## ***Interactive comment on “The impact of uncertain precipitation data on insurance loss estimates using a Flood Catastrophe Model” by C. C. Sampson et al.***

**C. C. Sampson et al.**

### **Response to comments from anonymous referee 1:**

Fig. 1. Revised: Figure 5

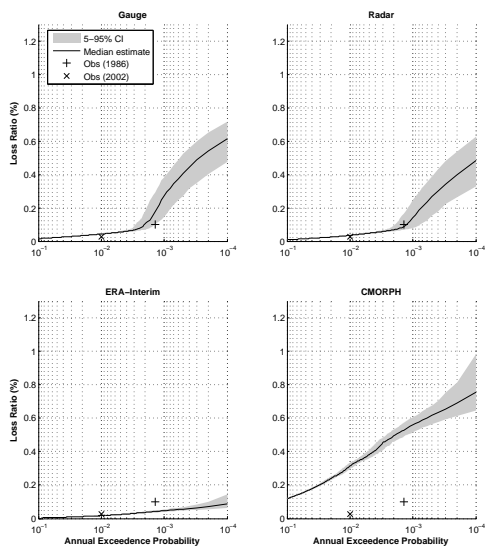
P78) Figures 5, 7 and 9 now gridded with consistent y-axis

Fig. 4. New: Figure 9

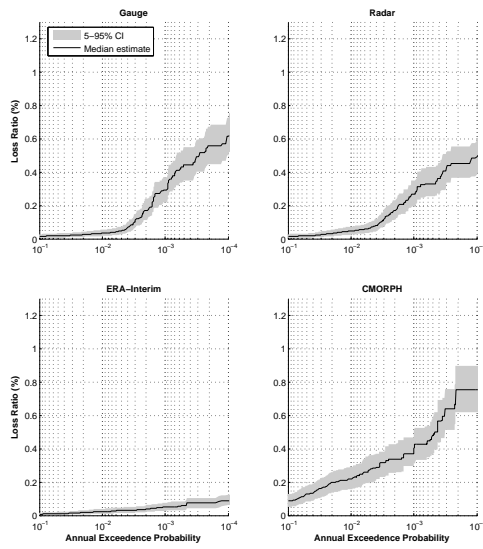
1) We have now incorporated vulnerability uncertainty into the paper. The relevant literature review has been extended slightly in section 1.3, the method is described in 2.2.3, the results are presented in 3.4 and the discussion and conclusions have been updated. A new figure (figure 9) has been added.

1) Vulnerability model uncertainty now included. See response to question 1 from referee 1.
